MERCY HOSPITAL MEDICAL CENTER
Department of Pathology

Re: Amendment to License 14-01137-01

We request amendment to our radioactive materials license #14-01137-01 for the following:

CHANGE IN LOCATION OF RIA DEPARTMENT: Enclosed please find a facility sketch representing the design of our new RIA Department. The storage refrigerator will remain in its present location.

Proposed
New
RIA
Area
Approx
15' x 25'

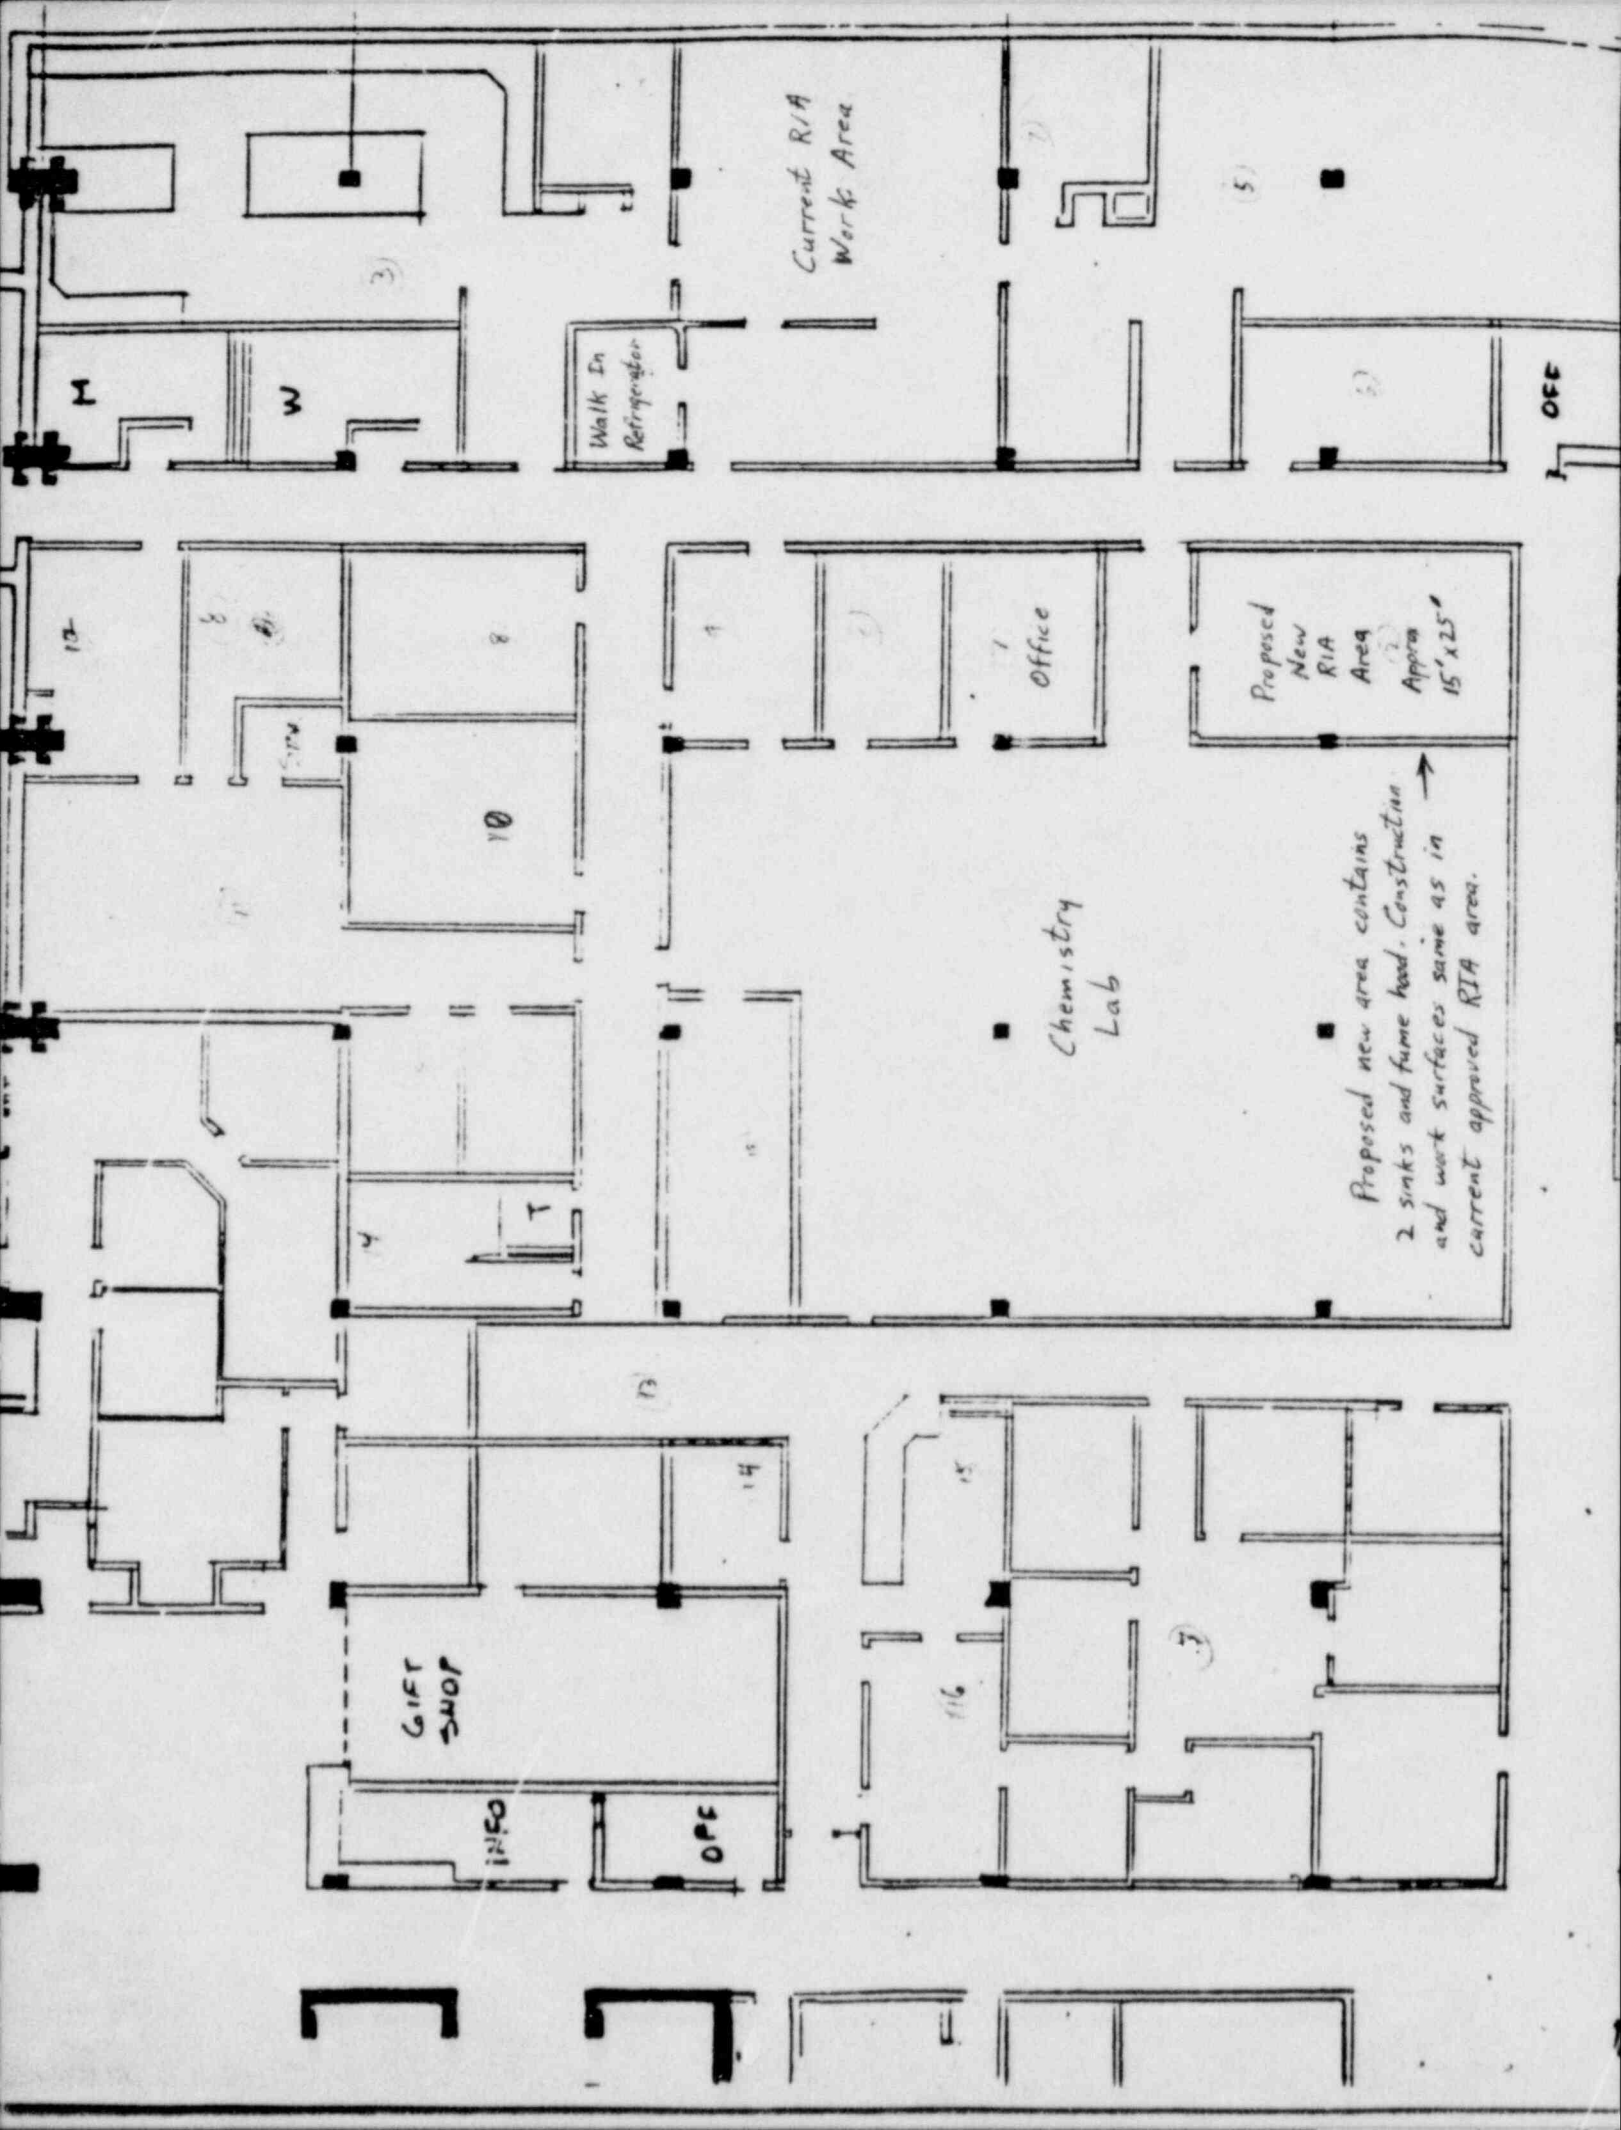
Proposed new area contains
2 sinks and fume hood. Construction
and work surfaces same as in
current approved RIA area.
